Amendments to the 2002 Water System Standards

BOARD OF WATER SUPPLY KA 'OIHANA WAI CITY AND COUNTY OF HONOLULU

March 18, 2025

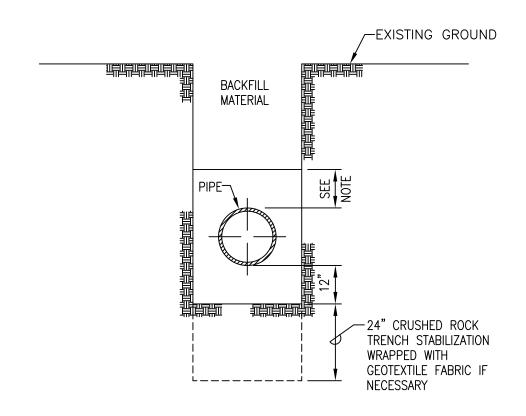
Delete Standard Detail P10 TRENCH BACKFILL and replace with the enclosed Standard Detail P10 TRENCH BACKFILL (2016 Revision) which reflects the increase in cushion material below the pipe to 12 inches.

Polymer Concrete Type X and Type B Meter Box and Cover

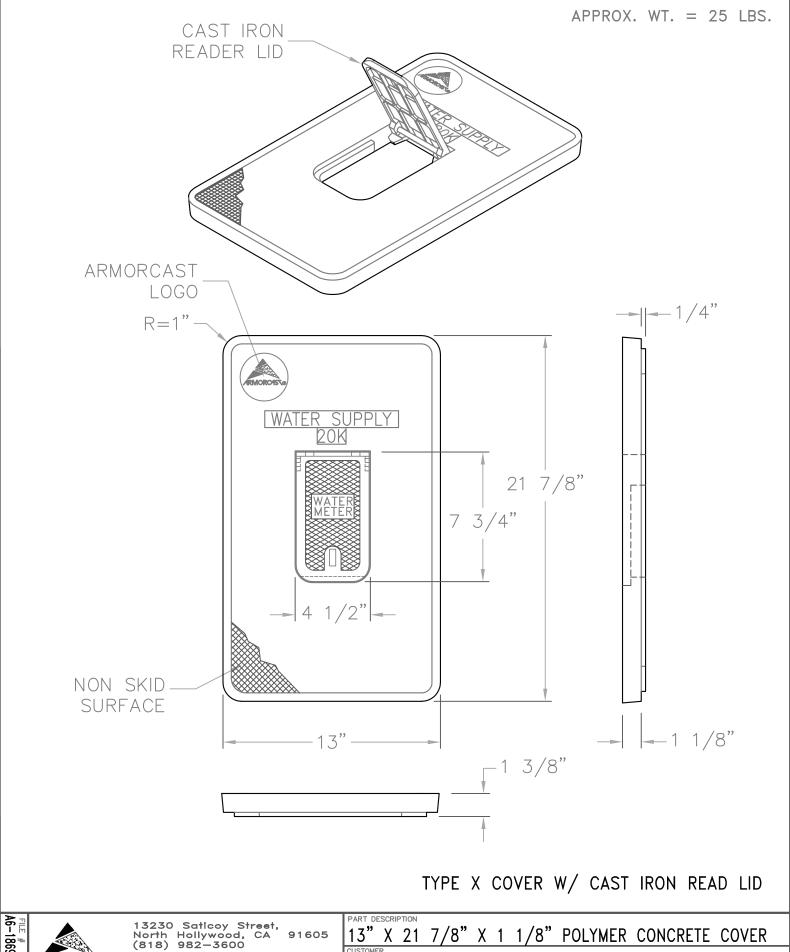
Effective immediately for Oahu only, all Polymer Concrete Type X Meter Box Covers shall be furnished with a cast iron reader lid as shown on the enclosed Drawing No. A6001869TRCI.

TYPICAL ELECTRONIC MARKER INSTALLATION

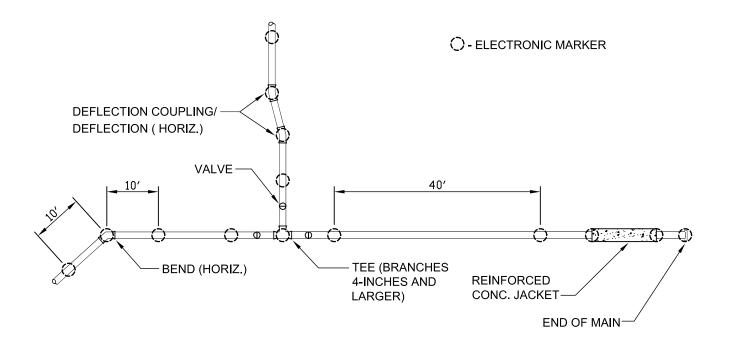
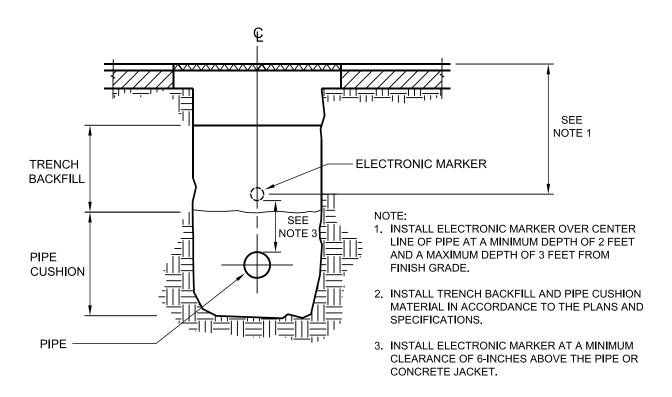
- a. One marker at all changes in horizontal alignment.
 - (1) Tees with branches 4-inches and larger
 - (2) Bends
 - (3) Deflection couplings
 - (4) Deflections at joints
- One marker 10 feet prior to and one marker 10 feet after a change in horizontal alignment unless markers are required within the 10 feet distance.

- c. On straight runs, markers shall be placed at a maximum distance of 40 feet.
- d. One marker at the end of all mains.
- e. Markers at the beginning and end of all concrete jackets.
- f. Markers at the beginning and end of all sections of mains under concrete pavement.
- g. One marker at the connection of the new main to the existing main.
- h. Markers shall not be placed at crossings with electrical duct lines, gas lines or telephone duct lines. Install markers at a minimum clearance of 5 feet from these utility crossings.

Contractor shall test the electronic markers prior to installation to verify proper operation. BWS personnel shall verify the number and locations of placed electronic markers prior to final paving.
